January 31, 1997
Fort St. Vrain
P-97007

**SUBJECT: Response to NRC Comments Regarding the Proposed Sampling
and Survey Plan for the FSV Effluent Pathway**

**RESPONSE TO NRC COMMENTS PROVIDED
IN LETTER DATED JANUARY 8, 1997**

**REGARDING PROPOSED SAMPLING AND
SURVEY PLAN FOR FORT ST. VRAIN
LIQUID EFFLUENT PATHWAY**

Figure 1-1
TEDE Based on Maximum Weighted Mean
100 Square Meter Area, Assumed Uniform Distribution Over 207,300 Square Meters

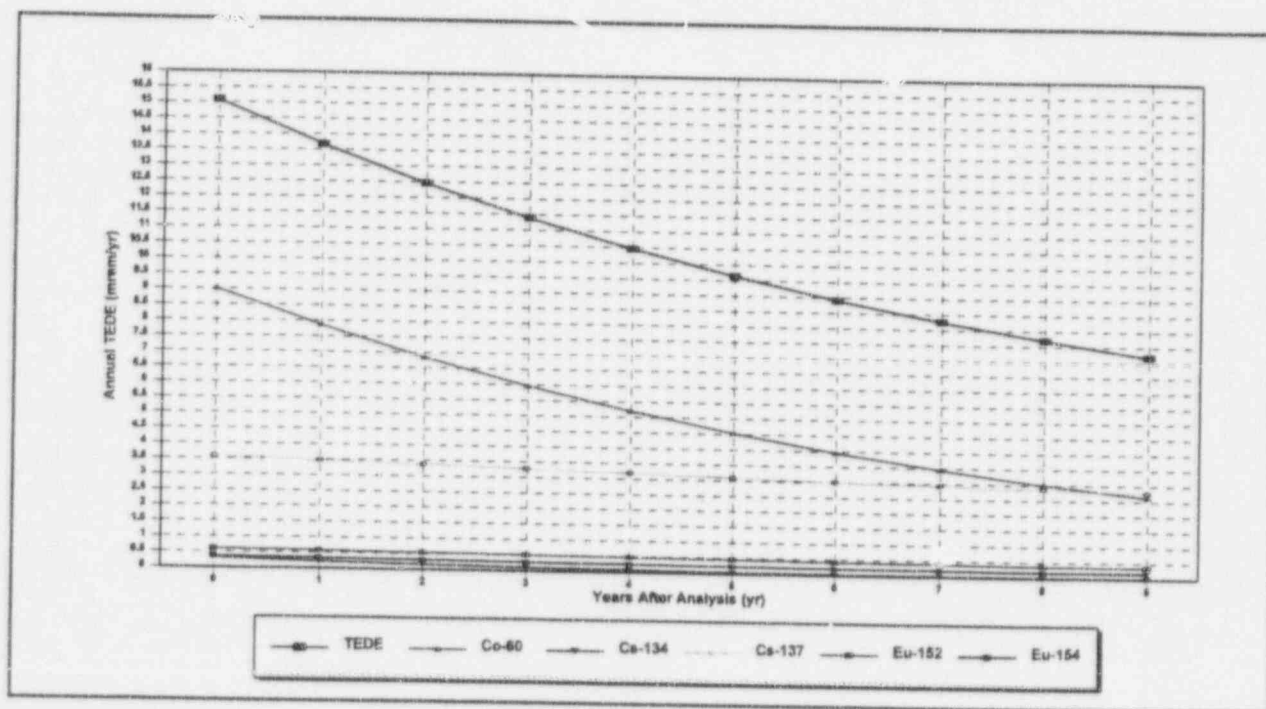
The RESRAD analysis for determining the site-specific guideline values used a scenario that assumes the open land areas will continue to be used as pasture land. Additional information is needed to support the assumed future land use and potential future dose to members of the public. PSC should use the default parameters from Scenario C of PG-8-08 to determine the most conservative unrestricted use dose and compare this dose with the dose using the site-specific guideline values PSC believes to be more realistic. Approval of the alternate scenario will depend on the magnitude of the differences between the baseline and guideline values, the time required for the dose from Scenario C to be reduced to acceptable levels by radionuclide decay (which provides an indication of how long the alternate land use scenario would need to be in place), and the strength of the justification for the alternative scenario.

For evaluation of the maximum weighted mean, the averages of each of the nuclide concentration from the Investigation samples collected within the 100 square meter area were used for the RESRAD analysis. The resulting estimate of the potential dose using PG-8-08, scenario C assumptions is 15.1 mrem/year at $t=0$ and is shown in Figure 1-1. After a period of approximately 4.5 years, the dose is reduced to 10 mrem per year. The RESRAD summary report has been included as Attachment 1.
